COUNCIL ASSESSMENT REPORT
SYDNEY WESTERN CITY PLANNING PANEL

PANEL REFERENCE & DA NUMBER	PPSSWC-334 – DA-50/2021/A
PROPOSAL	<p>Modification to Development Consent DA-50/2021 under Section 4.55 (2) of the Environmental Planning and Assessment Act 1979, for:</p> <ul style="list-style-type: none"> • Reconfiguration of internal apartment layouts including balcony design. • Revised basement ramp gradients with changes of basement levels, stormwater arrangement and OSD tank level and dimension adjusted. • Reconfiguration of car park layout to accommodate structural columns. • Site works including amendments to access ramp, retaining walls to accommodate revised ground level, revised front fence to accommodate services including hydrant booster assembly. • Amendment to Garbage storage and deletion of waste chutes. • Inclusion of lift overrun. • Amended façade materials and finishes. • Landscape design including the provision of an external bicycle parking area. • Amendment of Condition 21, 25,60, 62,151 and 179 • Deletion of Condition 155.

ADDRESS	23-25 Charles Street, Liverpool Lot 1 and Lot 2 DP500066.
APPLICANT	Hume Community Housing Association
OWNER	Hume Community Housing Associati

Figure 18: Proposed S4.55- Floor Plan L6 – Revision 3

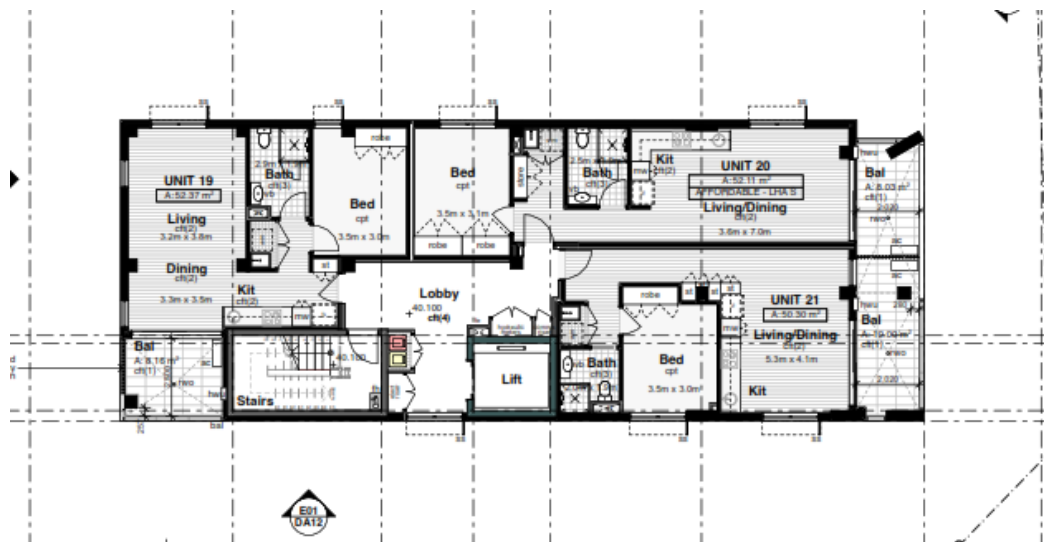
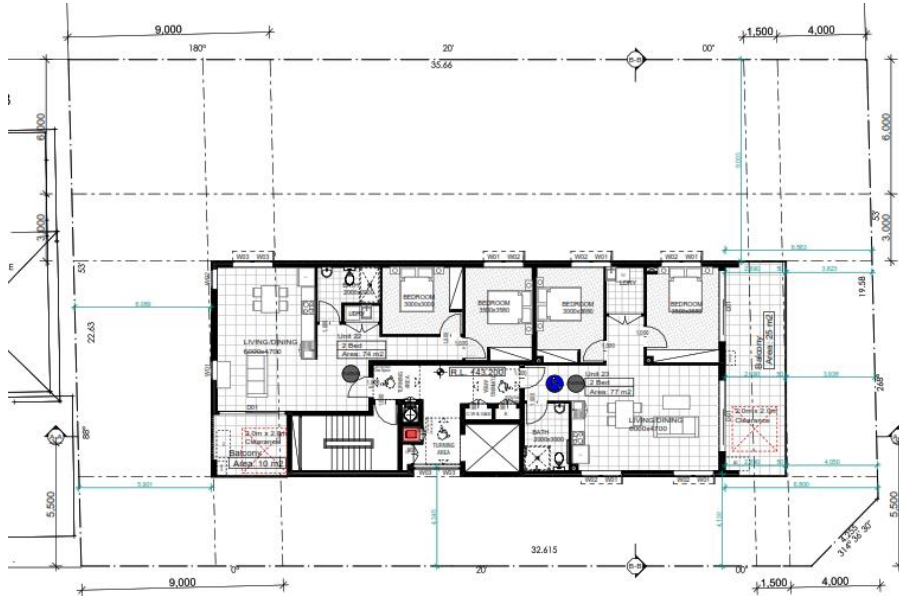
- The proposed modification amends the approved Units GFA:
 - Unit 19 approved GFA of 52sqm and is now 52.42sqm,
 - Unit 20 approved GFA of 51sqm and is now 52.11sqm,
 - Unit 21 approved GFA of 50sqm and is now 50.31sqm,
 - This is an increase slightly in GFA which impedes the FSR across the site.
- The modification also includes the amending of the balconies GFA:
 - Unit 19 has an approved Balcony area of 9sqm and is now proposed as 8sqm.

Figure 22: Proposed S4.55 -Communal Open Space Plan- Rooftop Terrace

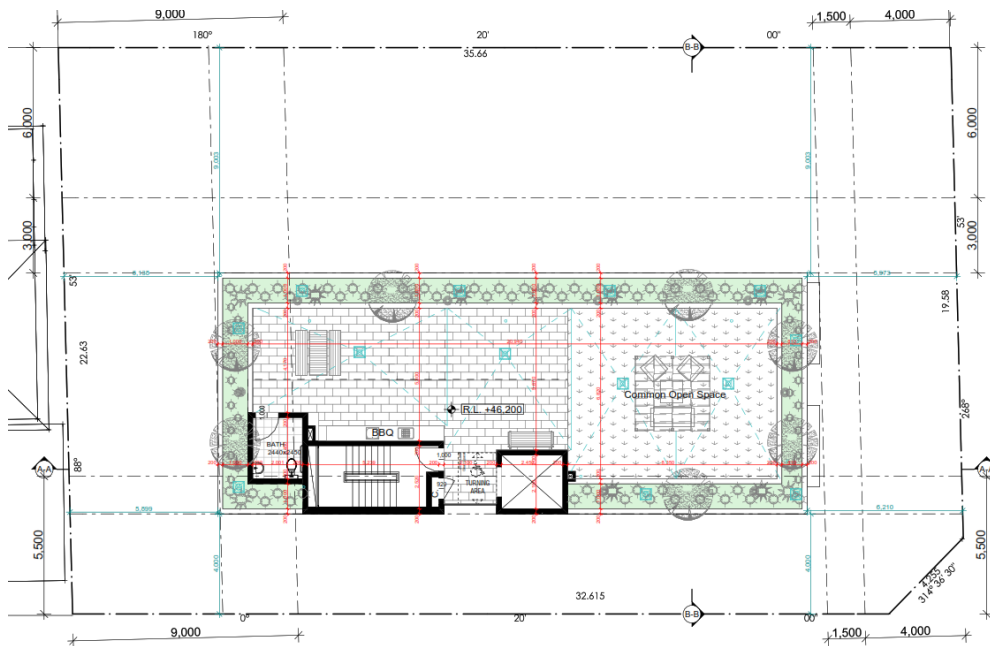
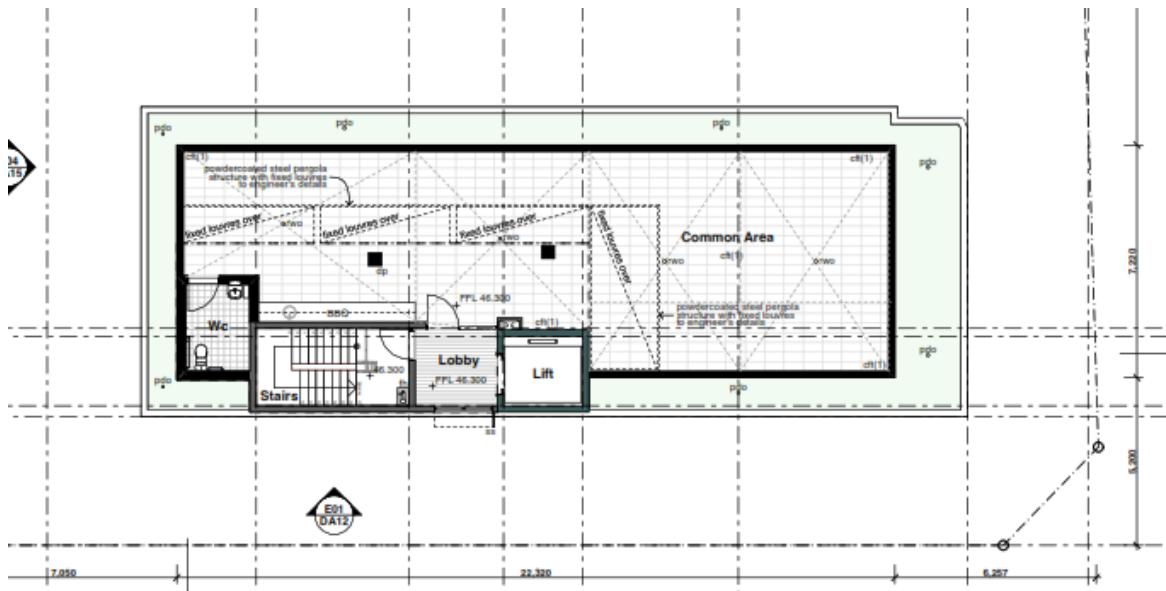
In light of the above, it is evident the proposal is deficient as it does not address or encapsulate the full extent of the modifications proposed.
